NUMBER: SB 550-21-002, Rev A
MODEL: ECLIPSE 550®
SUBJECT: Gearbox Venting Improvement

This Service Bulletin improves the performance of the gearbox venting on the GDCA.

Figure 1. Parts Removal

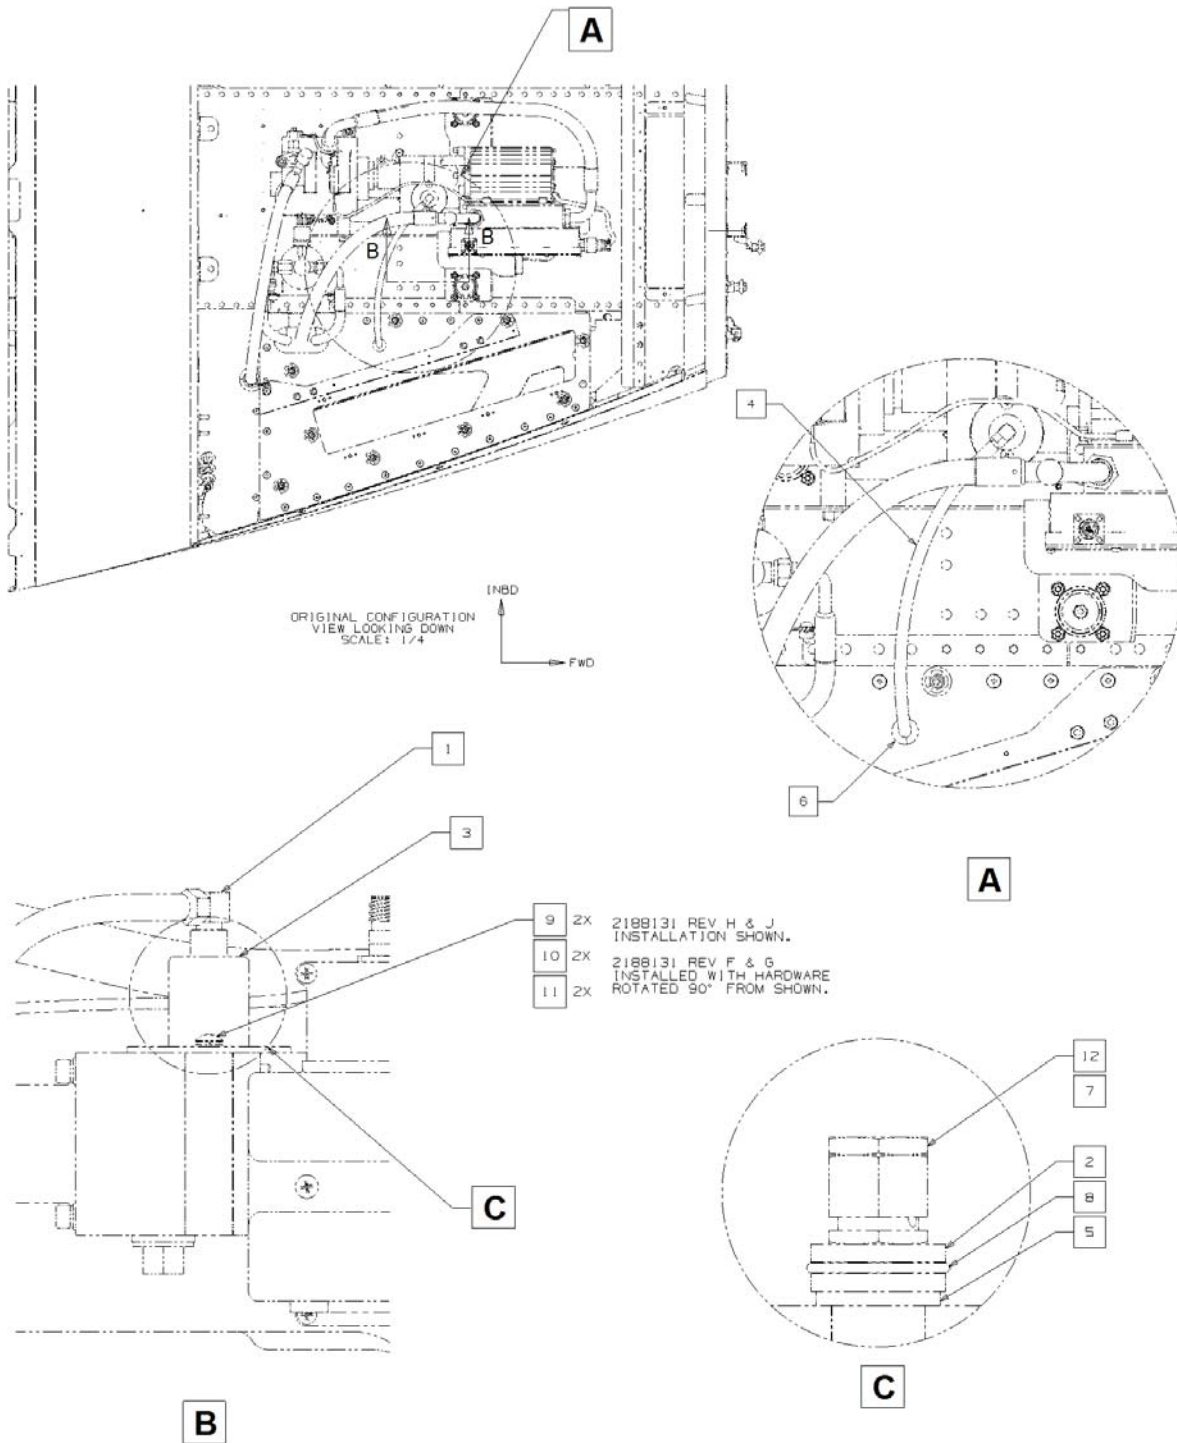
- (1) Clean off the sealant which held the tube to the grommet. Remove tube (2188515) and grommet (32-114432-2002), refer to [Figure 1](#).
- (2) Remove cover (2188279 or 2188281) with attached elbow (1ZJU4) and attaching hardware: screws (MS35206-242, X2), lock washers (MS35338-42, X2), and washers (NAS620C8L, X2), refer to [Figure 1](#).

- (3) From under the cover, remove the vent valve (YA-8024), o-ring (40-2556-G20), spacer (2188277), o-ring (MS28775-017), and gasket (2188527), refer to [Figure 1](#).

Figure 2. Parts Installation

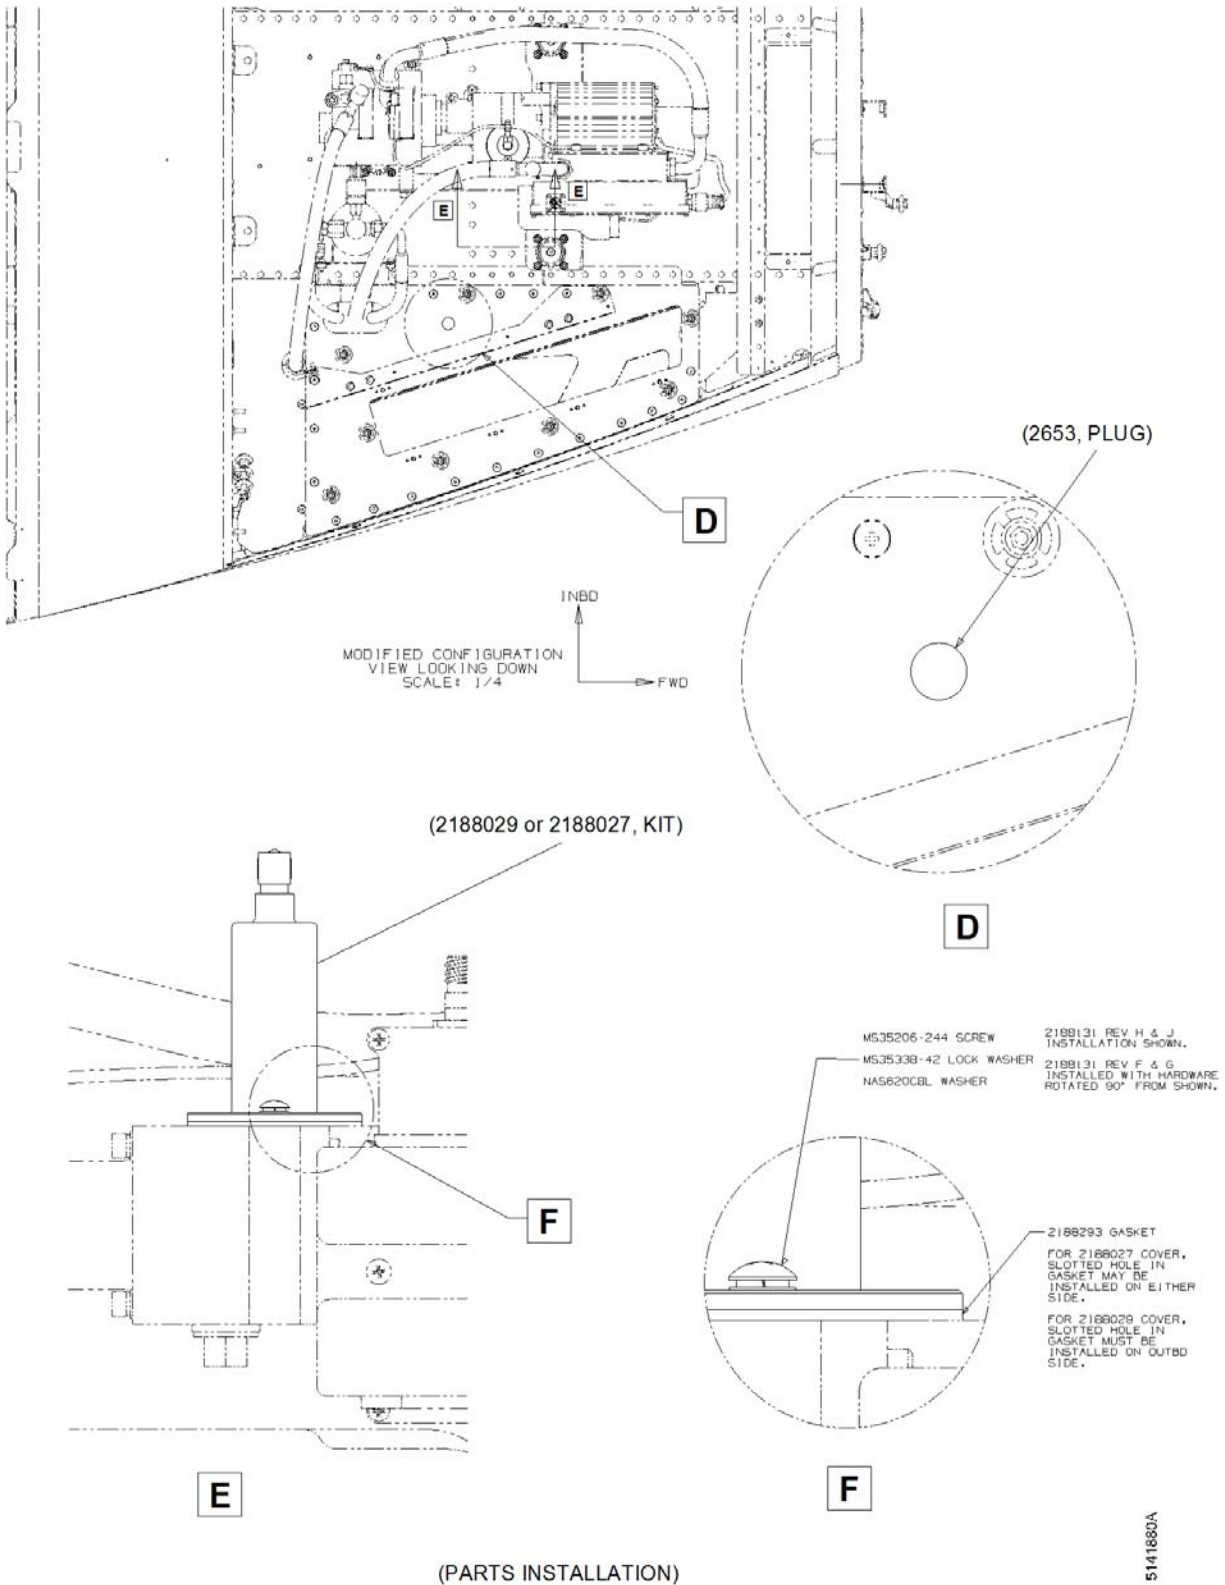
- (4) Clean up any oil found on top, bottom, or sides of the gearbox.
- (5) Install vent cover kit (2188027 or 2188029) with elbow installed, as shown, with gasket (2188293) and hardware as specified on [Figure 2](#), view "F". Apply Loctite 242 to screw thread and torque to 10–13in-lbs, refer to [Figure 2](#).

- (6) Install plug (2653) in existing grommet hole. Secure plug in hole by applying a fillet seal using RTV 106, refer to [Figure 2](#).
